# **APPLICANT'S RESPONSES TO RELEVANT REPRESENTATIONS AND ADDITIONAL SUBMISSIONS**

## **Drax Bioenergy with Carbon Capture and Storage**

**Document Reference Number: 8.3**

**Applicant: Drax Power Limited**

DRAWING NUMBER  
EN010120-PA-FCA-EC-30

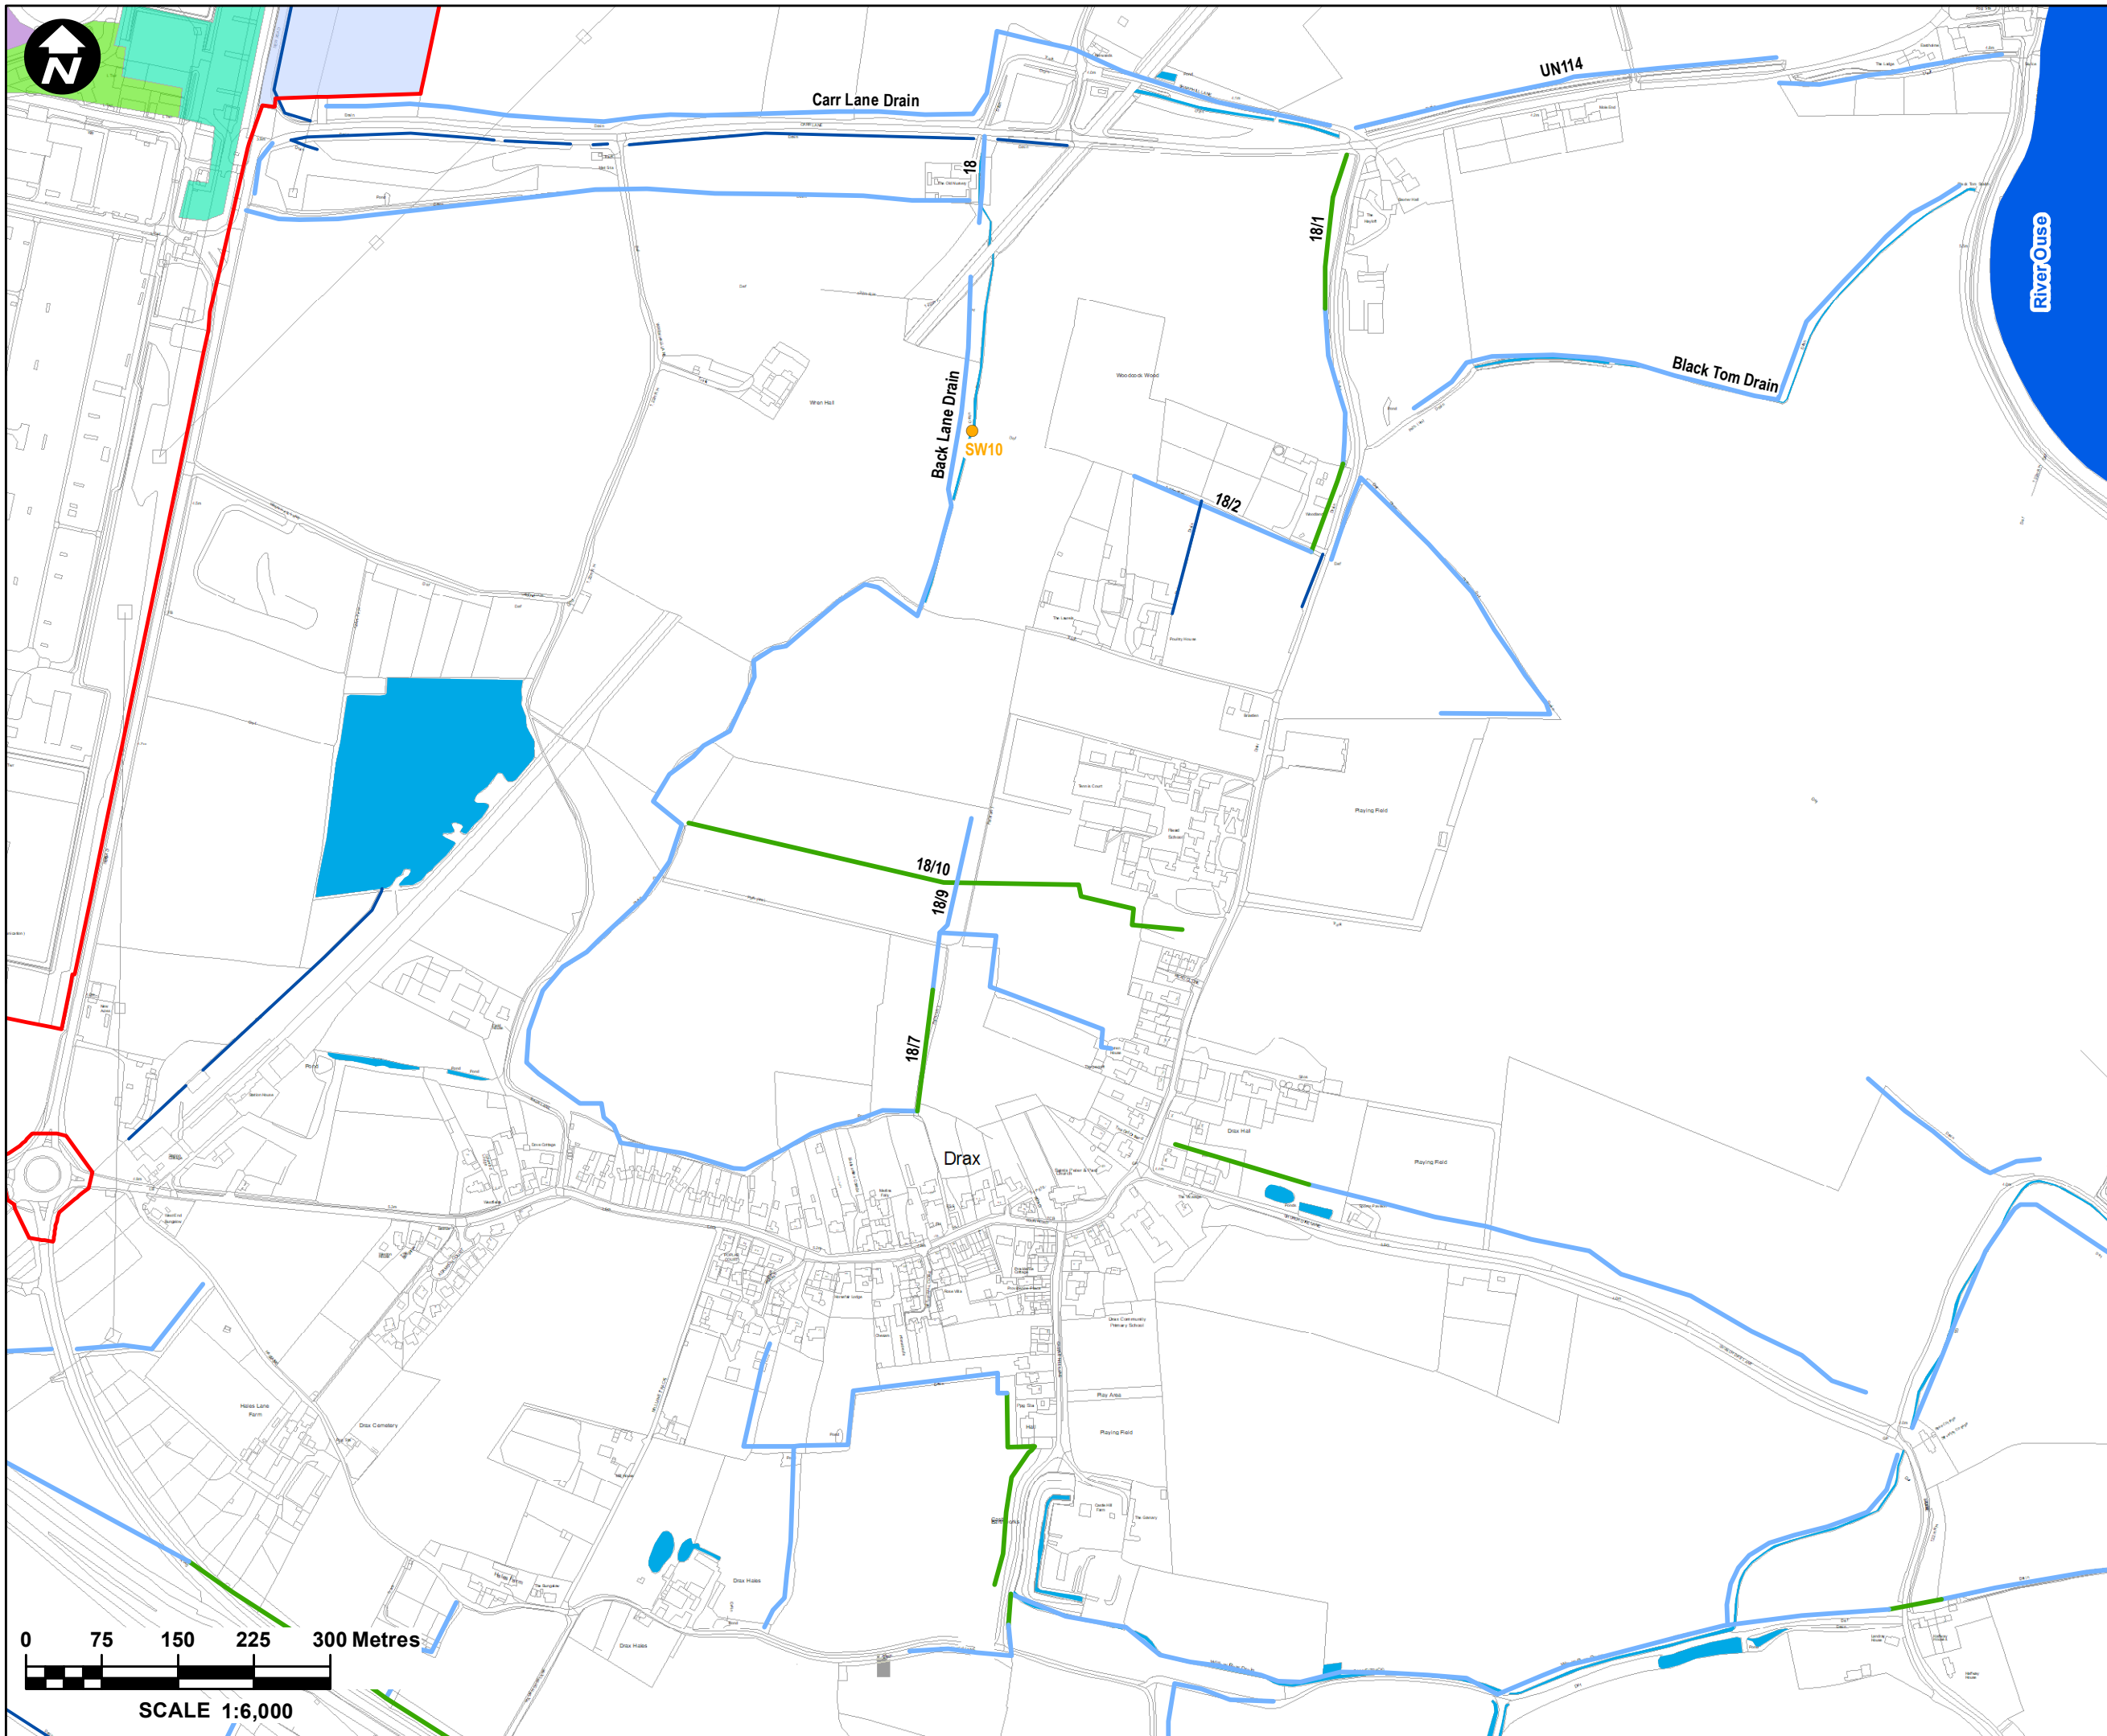
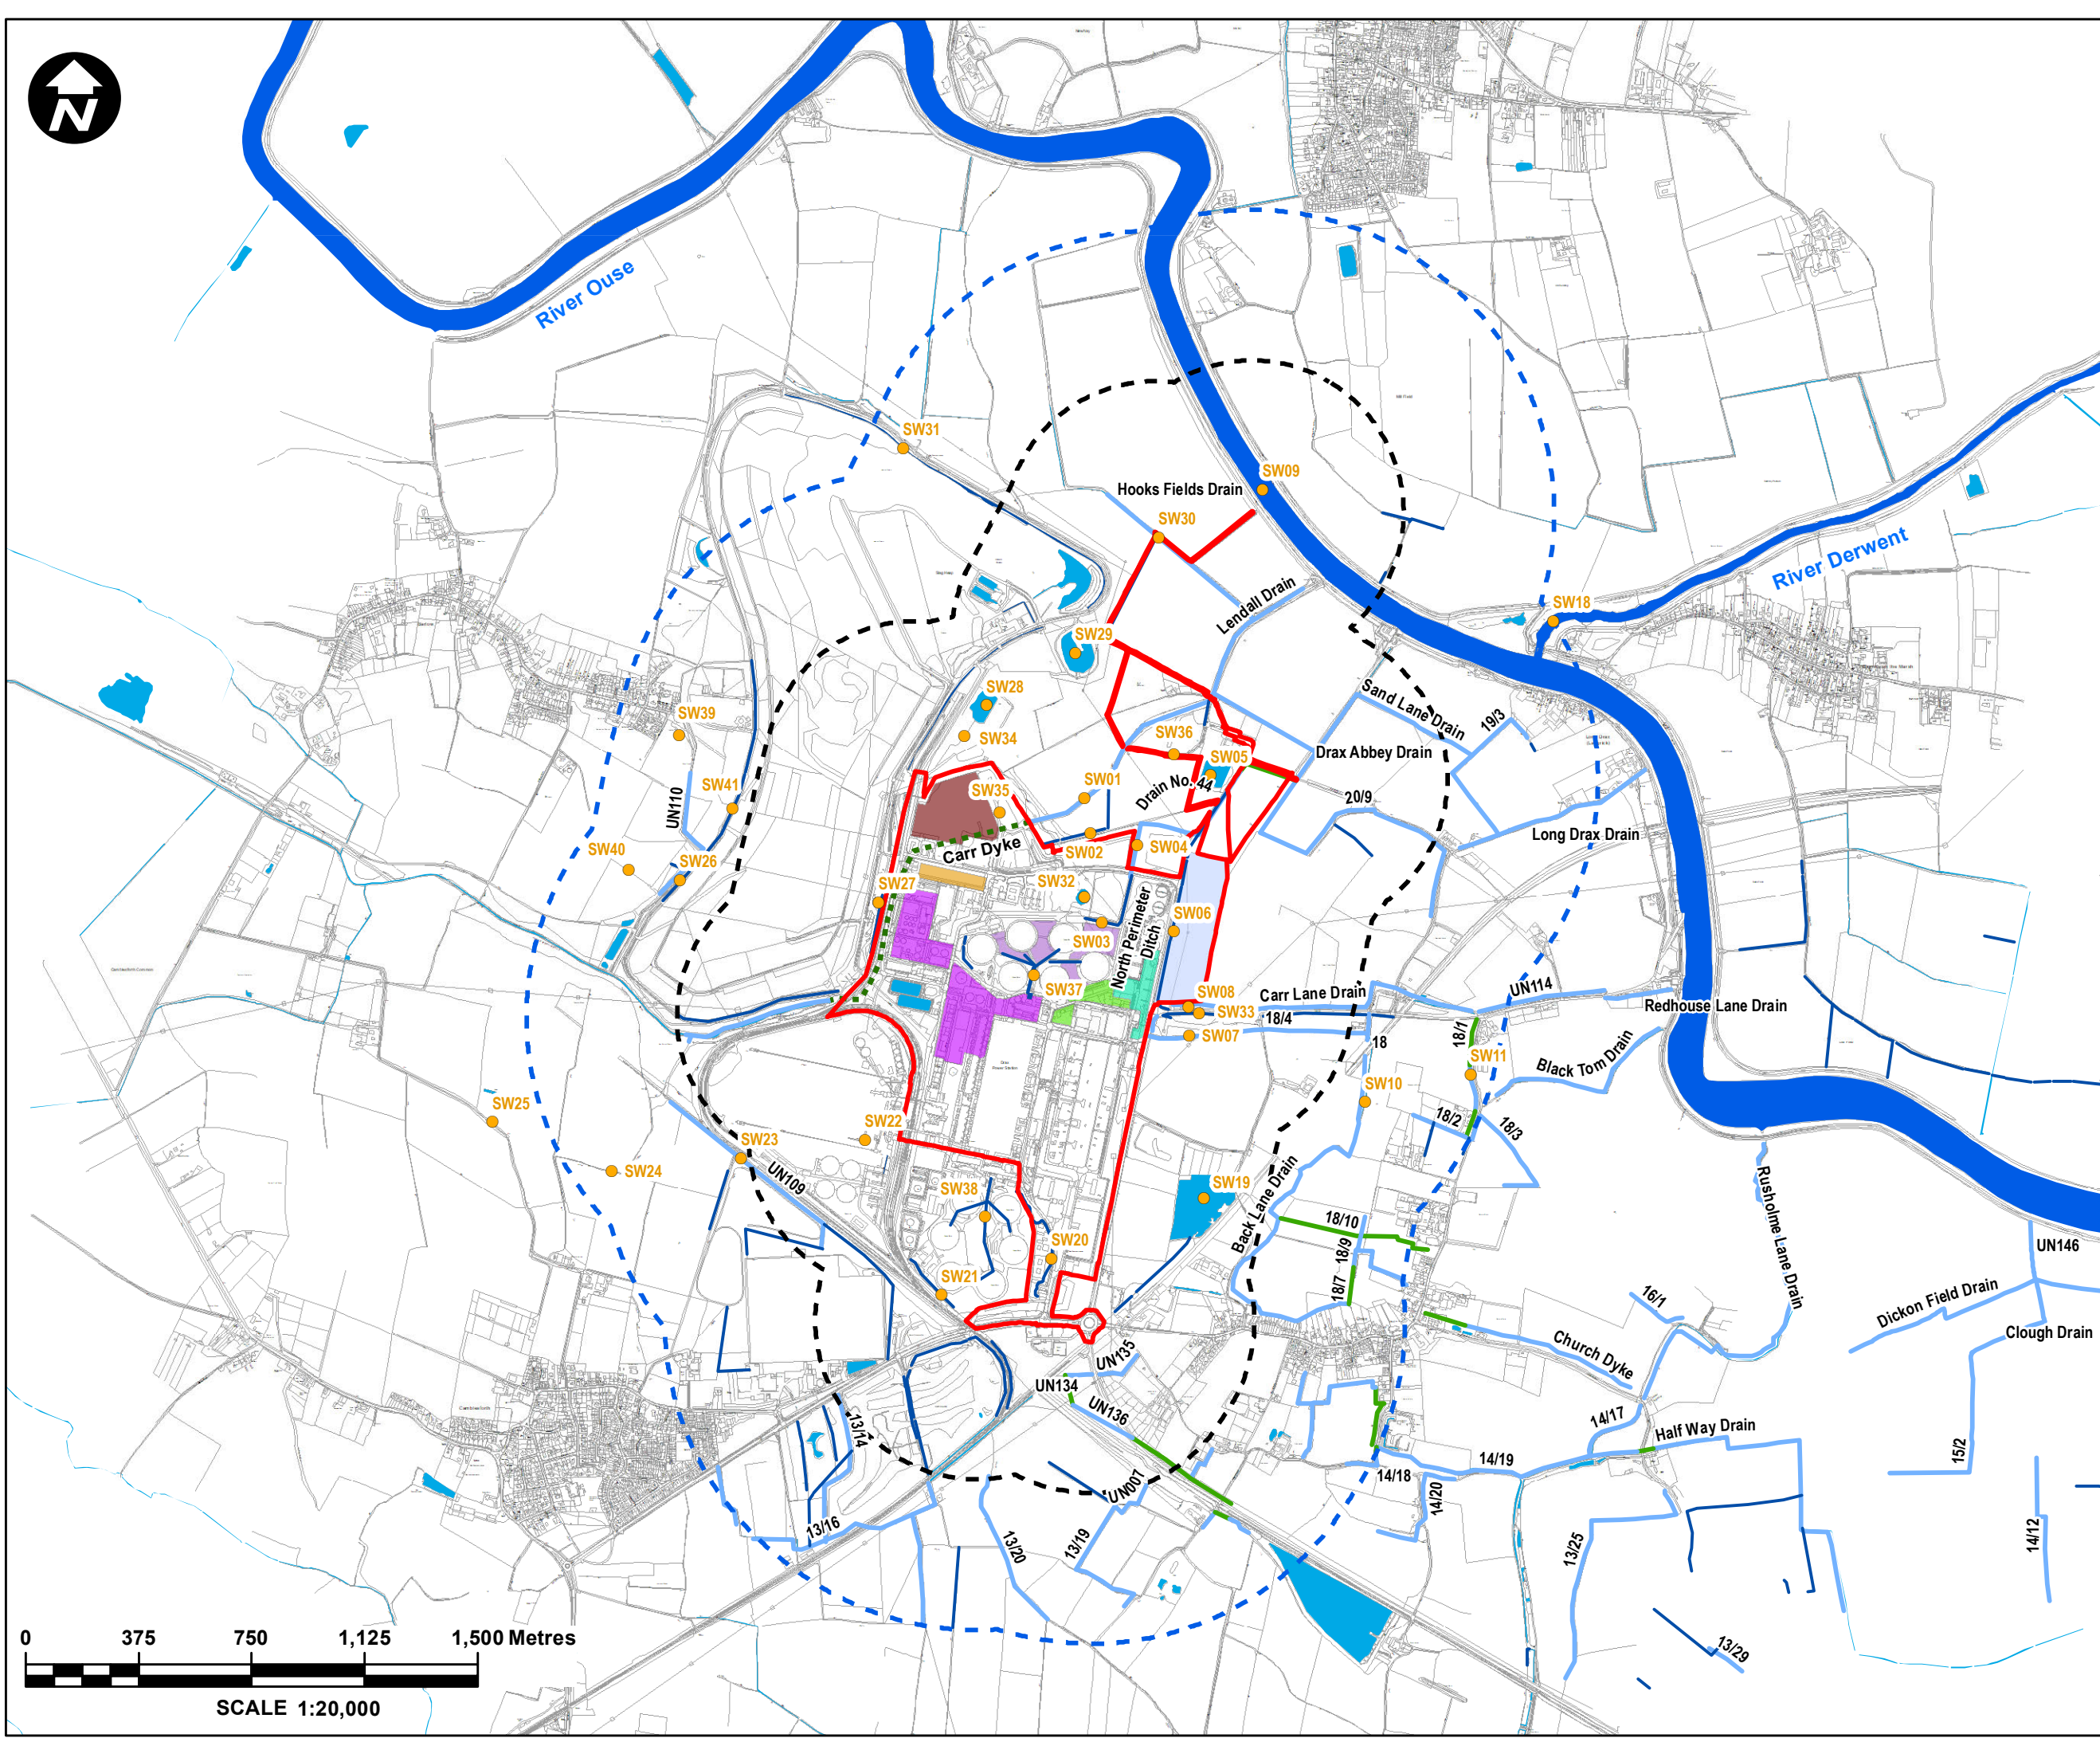
4.5	<p>Table 12.6 Surface Water Features within the study area that have the Potential to be Affected by the Proposed Scheme. Several of the ponds within this table which have a recorded presence of Great Crested Newt are not considered as 'sensitive receptor'. We disagree with this as they may be a habitat of the Great Crested Newt, which is a protected species and therefore a 'sensitive receptor'.</p> <p>This issue has also been raised in the Additional Submission Document Ref AS-040.</p>	<p>Whilst these ponds could be considered as a sensitive receptor as the presence of Great Crested Newt has been recorded / provide suitable habitat, they are not likely to be affected by the construction of the Proposed Scheme given that they are separated from the Proposed Scheme and Construction Areas, by an earth embankment, as shown in the image below, which would prevent any pollutants / contaminants which are accidentally released from the construction of the Proposed Scheme from reaching them.</p>

Figure 1. Illustration of modelled operating hours for the 4 x Units in the Full Load and Mid Merit Scenarios

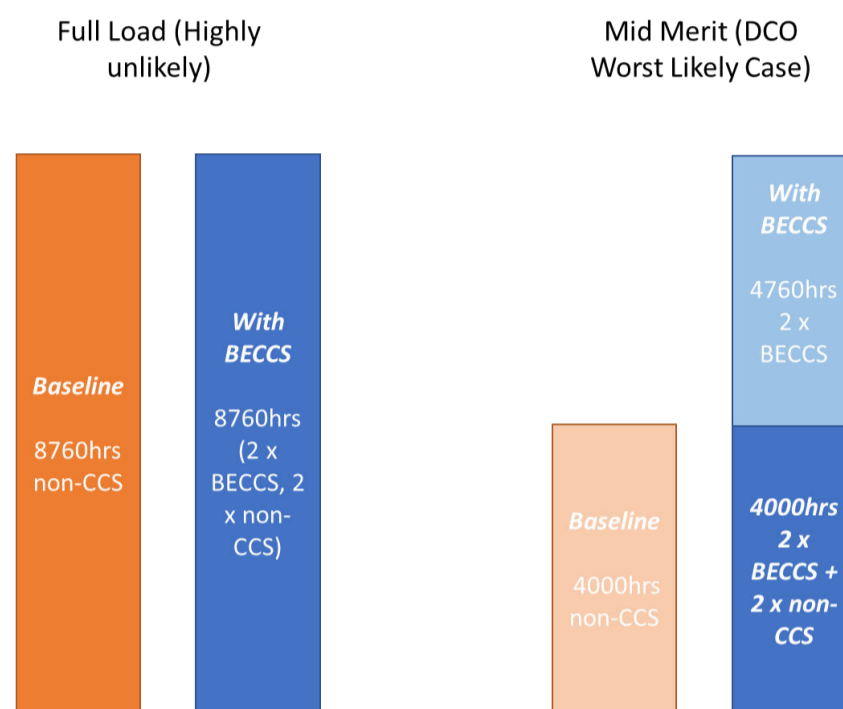
A standard assessment for a power station would be based on the full load operation of the power station both with and without any proposed changes. Since the Proposed Scheme involves fitting CCS to existing generation units, the Full Load operations involve 8760 hours of operation of 4 x units in both the baseline and With Scheme scenarios, with 2 of these units being BECCS units with the Proposed Scheme. This is illustrated in the left section of Figure 1.

With the Proposed Scheme and the relevant Government support mechanism (a Contract For Difference (CFD) which encompasses both power and carbon) in place it is highly likely that the operation of units with CCS will be more economically advantageous than operation of the non-CCS units since support on these current units will cease in 2027 and hence a future full load scenario is considered unlikely and a more intermittent operating regime would more likely result. To ensure a robust, worst-case assessment, a Mid-Merit scenario has been modelled as illustrated in the right-hand section of Figure 1. It involves 4 units (non-CCS) operating for 4000 hours in the baseline without the Proposed Scheme, and with the Proposed Scheme, the 2 x CCS units operating for 8760 hours (4000 h + 4760 h), and the 2 x non-CCS units operating for just 4000 of those 8760 hours.

Figure 2. Illustration of modelled air quality impacts for Full Load and Mid Merit Scenarios

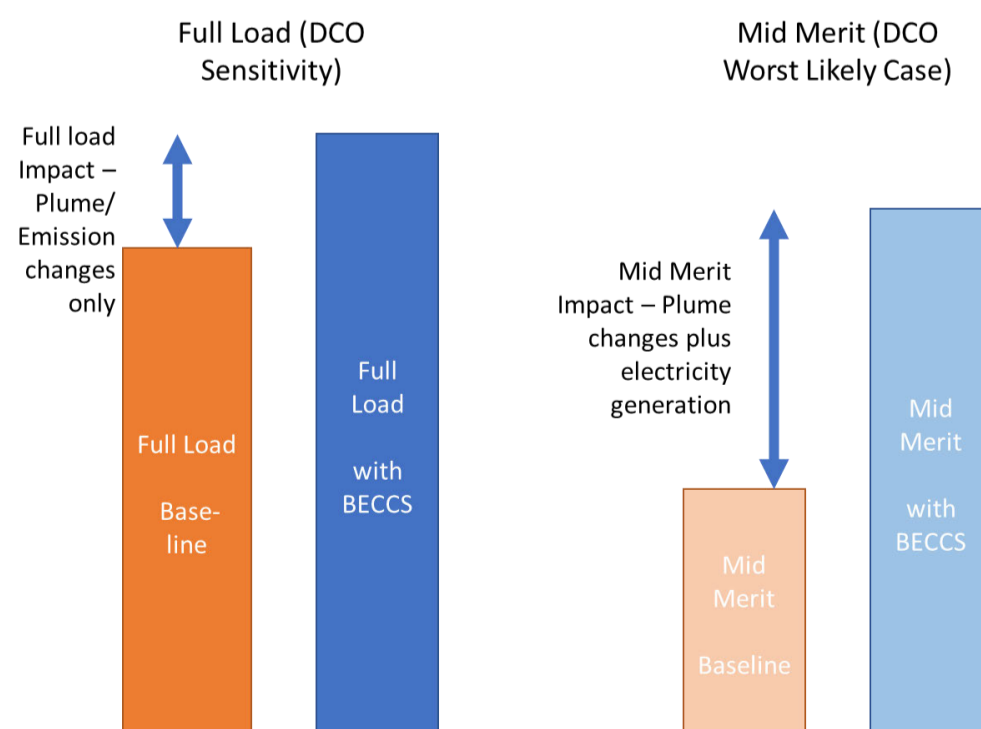
With an assessment based on Full Load operations, whilst the contribution of the plant to local concentrations of pollutants is maximised in both the Baseline and the With BECCS scenarios, the **impact** of BECCS is determined solely by the balance of the beneficial impacts of reduced pollutant concentrations and the adverse impacts of the change plume buoyancy (and a net slight disbenefit). This is illustrated in the left panel of Figure 2.

In the Mid Merit Case, the contribution of the plant to pollutant concentrations is reduced in comparison to the Full Load case, since the units are not all operating continuously in either Baseline or With BECCS scenarios. However, the **impact** of BECCS now includes both the plume/emission changes and the impacts of the likely increase in operating hours. This is illustrated in the right panel of Figure 2.

**Figure 3. Illustration of modelled air quality impacts for Mid Merit Scenario without 3 unit operations (as modelled for ES, DCO Worst Likely Case) and with part use of 3 unit operations (Alternative Likely Case)**

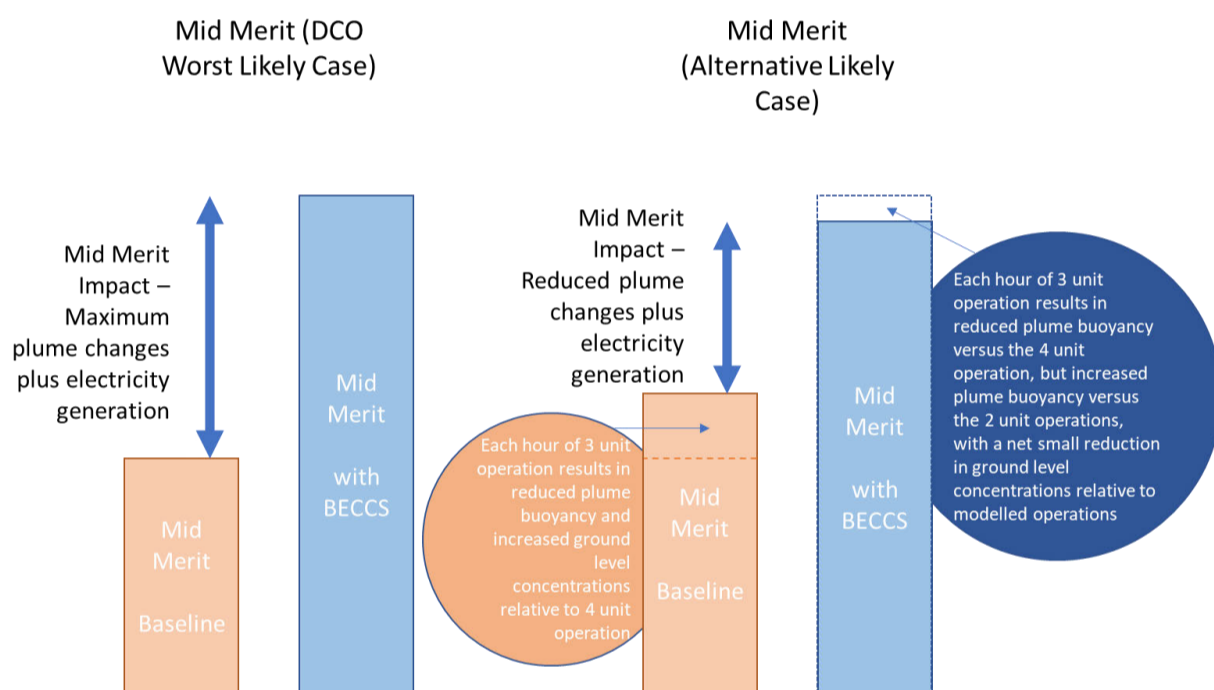
Such operations will lead to a reduction in the modelled impacts for the Mid Merit scenario. This is illustrated in Figure 3.

It must be noted that in the Baseline, moving any of the 4000 hrs for each unit operating from 4 to 3 unit operations (whilst maintaining the total operating hours/electricity production) results in **increased** process contribution at ground level because the buoyancy of the plume is reduced with 3 units in comparison to 4 units. For the with BECCS scenario, if you move from 4 unit operation to 3 unit operation, you must then replace one or more hours of 2 BECCS unit operation with 3 unit operation. Whilst the 4 to 3 unit operation change results in reduced plume buoyancy, the 2 to 3 unit change results in increased plume buoyancy, with the net effect that ground level concentrations decrease slightly. Overall the changes then result in a **reduced** impact in comparison to the modelled Mid Merit scenario.
